Agenda Item	5.1
Report No	PLN/025/25

HIGHLAND COUNCIL

Committee: North Planning Applications Committee
Date: 23 April 2025
Report Title: 23/02998/S36: Renantis (formerly Falck Renewables Wind Limited)
Land 1800M NE of 12 Upper Feorlig Dunvegan – Continued Item

Description: Ben Aketil Repowered and Extended Wind Farm – Decommissioning and removal of 12 turbines and related infrastructure, erection and operation of 9 turbines with a maximum blade tip height of 200m, up to 20MW Battery Storage System, anemometer mast, access tracks, up to two borrow pits and all associated infrastructure

TITLE: Figure 2.3:
Site Layout

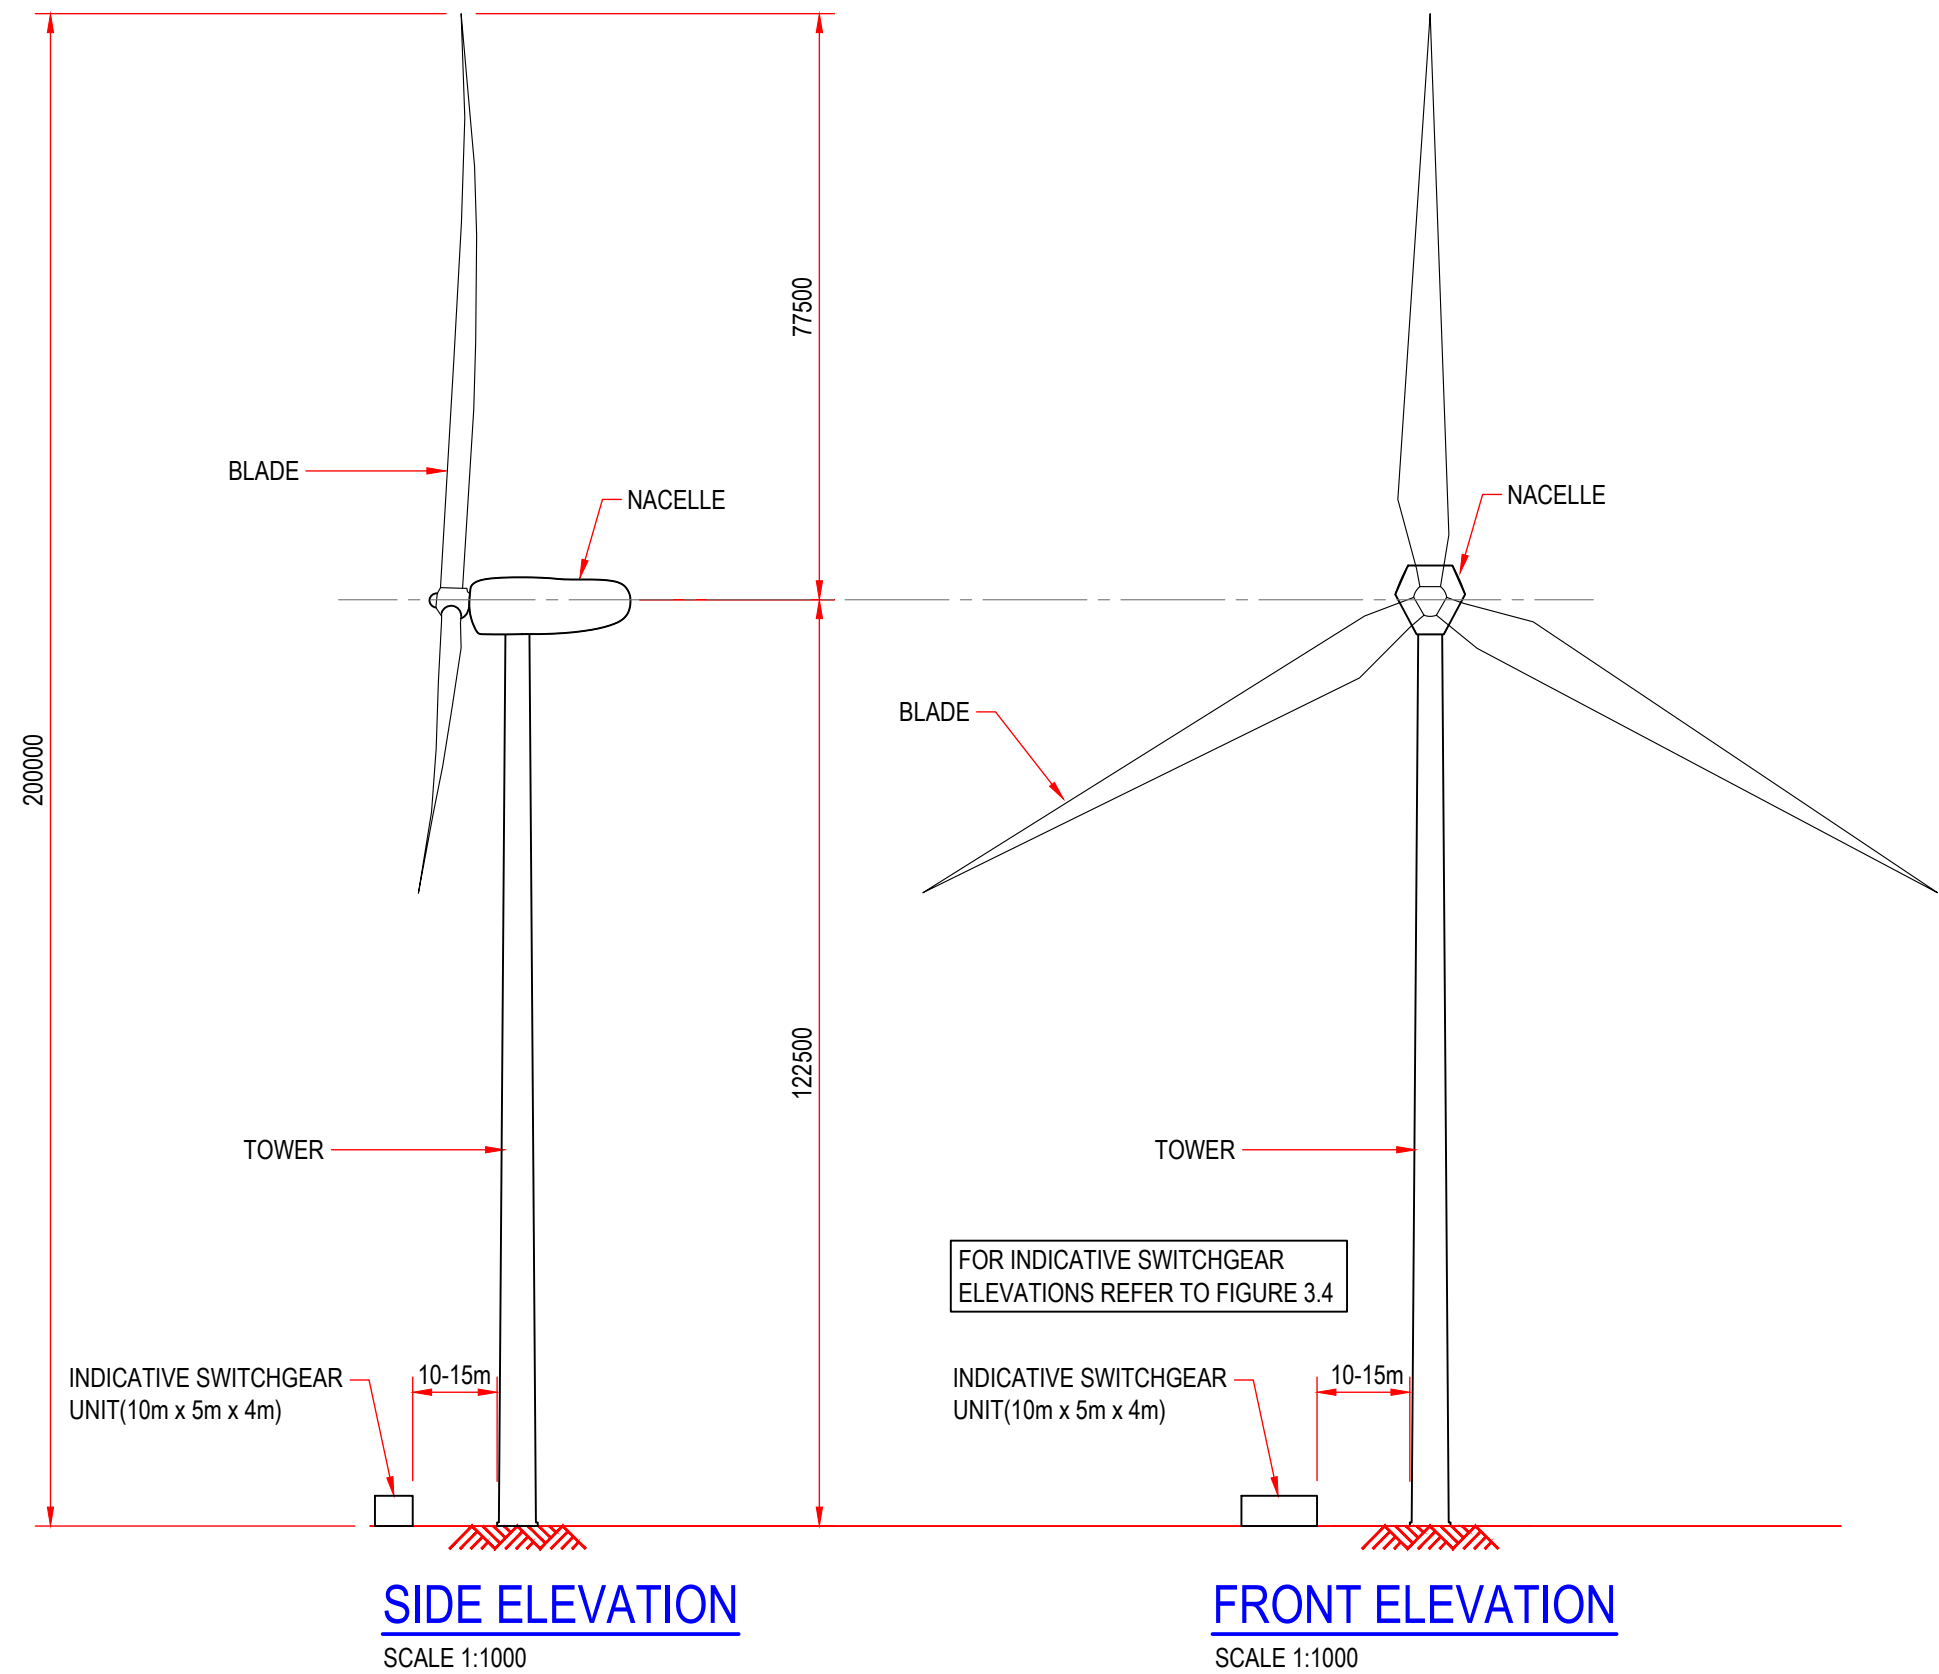
to advise that design modifications were required to tracks and the borrow pit location, with a complete repositioning of the borrow pit being required rather than micro-siting in order to minimise peat impacts. SEPA further advised that this information was to inform a revised Peat Management Plan as well as a Borrow Pit Restoration Plan as the proposed reuse of disturbed peat for restoration of the borrow pit of depths of up to 2 m was not an acceptable reuse of this peat.

- 8.18 In response to SEPA's concerns, the applicant provided a revised layout in the FEI with new track routes proposed to Ts 5 and 8 as well as to the southernmost construction compound along with the complete removal of borrow pit 2. Furthermore, the applicant is now proposing use of floating track on areas previously considered for cut and fill track. New peat probing data also provides more accurate data for peat disturbance associated with turbine and crane pad installation, which reduces peat disturbance volumes further. The revised figures show that a total volume of 86,800m³ of peat extraction will now be required as opposed to the initial volume 117,700m³, a reduction of 30,900m³. These revisions also remove infrastructure from within watercourse buffer zones.

- 8.19 In its response to the FEI, SEPA advises that there are still a number of locations where peat over 1 m will be impacted by the current layout but that, however, further revisions to layout, for this site-specific case, could be made post consent through the finalised Peat Management Plan and use of micro-siting. Consequently, SEPA withdraws its objection.

- 8.20 Nevertheless, SEPA still requires conditions to secure:
- its prior approval of the finalised Peat Management Plan;
 - the use of floating track on areas of deep peat as proposed in the FEI;
